FIRST PHASE OF JAMAICA PORTLAND CONTAINER TERMINAL

STATEMENT FOR CHANGING OF ENGINEERING SURVEY & GEOTECHNICAL INVESTIGATION

Fig. 1 The overall scope of the previous survey

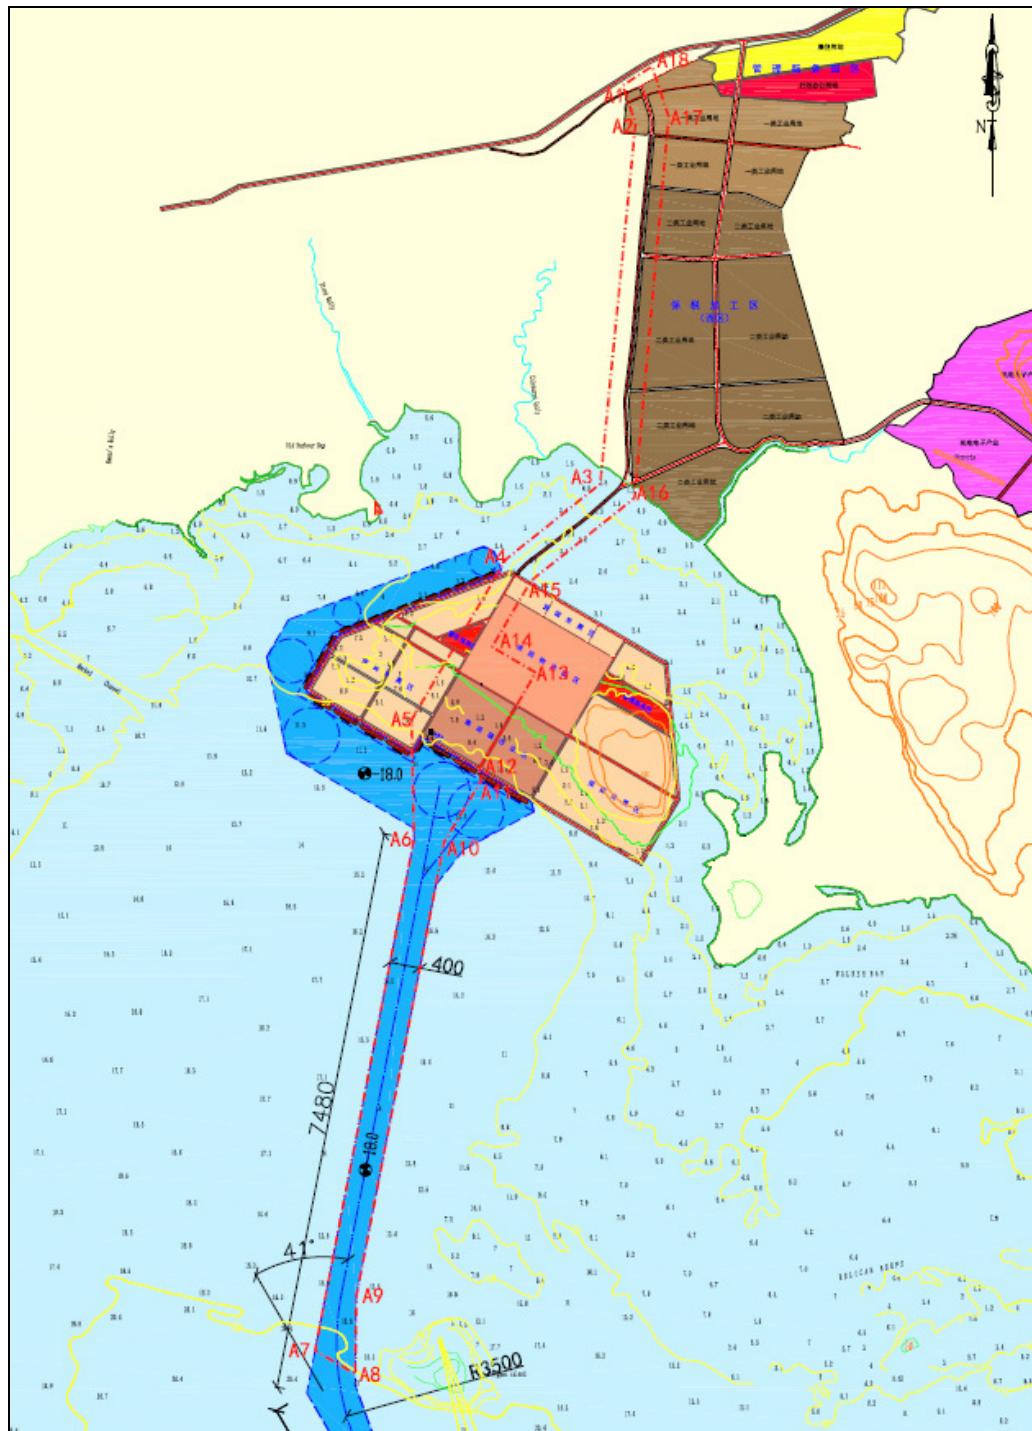
The **previous** area of topographic survey was 5.27 km², the **new area** is 5.89 km².

The **previous** area of bathymetric survey was 3.83 km²; the **new area** is 44.08 km².

The overall scope of the **previous** survey covers the connecting portion from point A1-A18 (For details, refer to the attached drawing Fig.1). The coordinates are shown as follows:

Fig. 2 The overall scope of the new survey

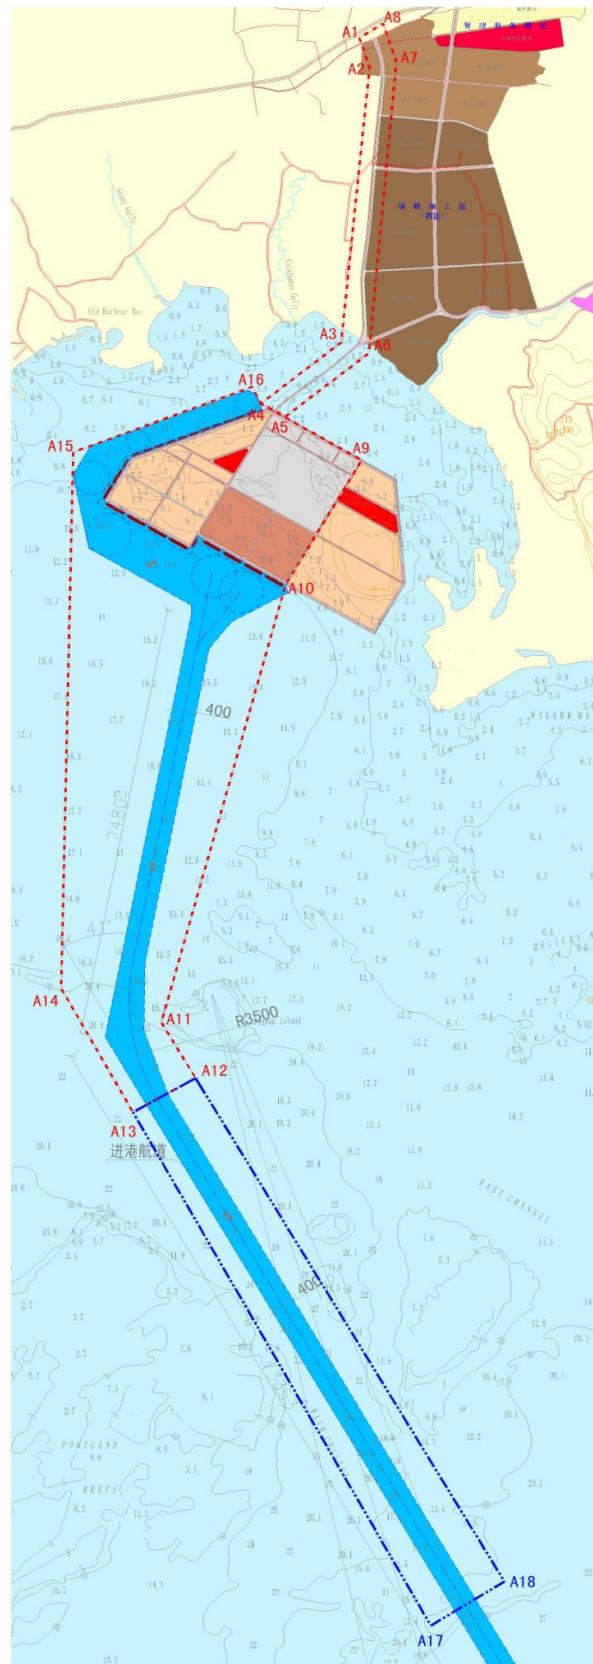
The overall scope of **new area** survey covers the connecting portion from point A1-A18 (For details, refer to the attached drawing Fig.2). The coordinates are shown as below:

Fig. 5 The comparison of the previous and new boreholes

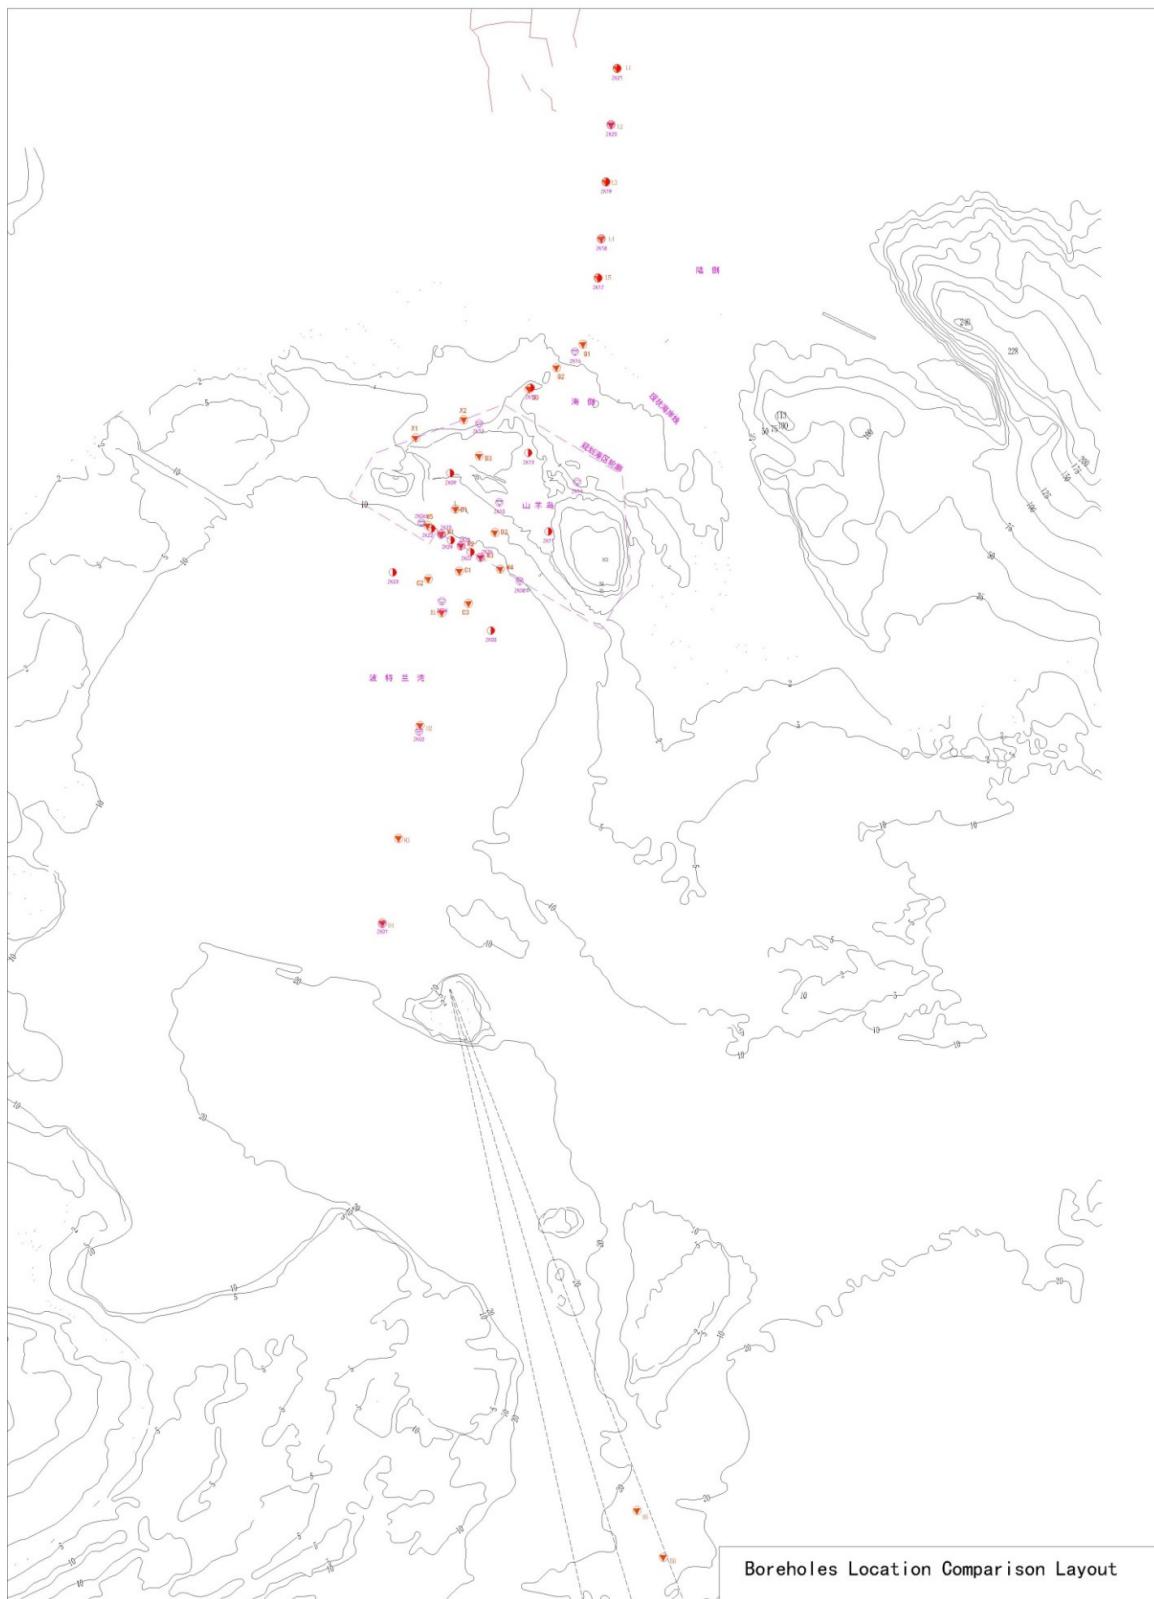
There are 26 boreholes based on the **previous** design location layout, 5 boreholes are on land, 4 boreholes are on Goat Island, the others 17 boreholes are in the offshore area. The **previous** boreholes location layout is illustrated in Fig. 3.

According to the engineering design requirement, the **new** number of boreholes has now changed to 27, but the 5 boreholes on land remain at the same location. Only one borehole will be done on Goat Island, while the other 21 boreholes will be location in the sea. The new boreholes location layout is illustrated in Fig. 4.

The comparison of the **previous** and **the new** boreholes are illustrated in Fig. 5.
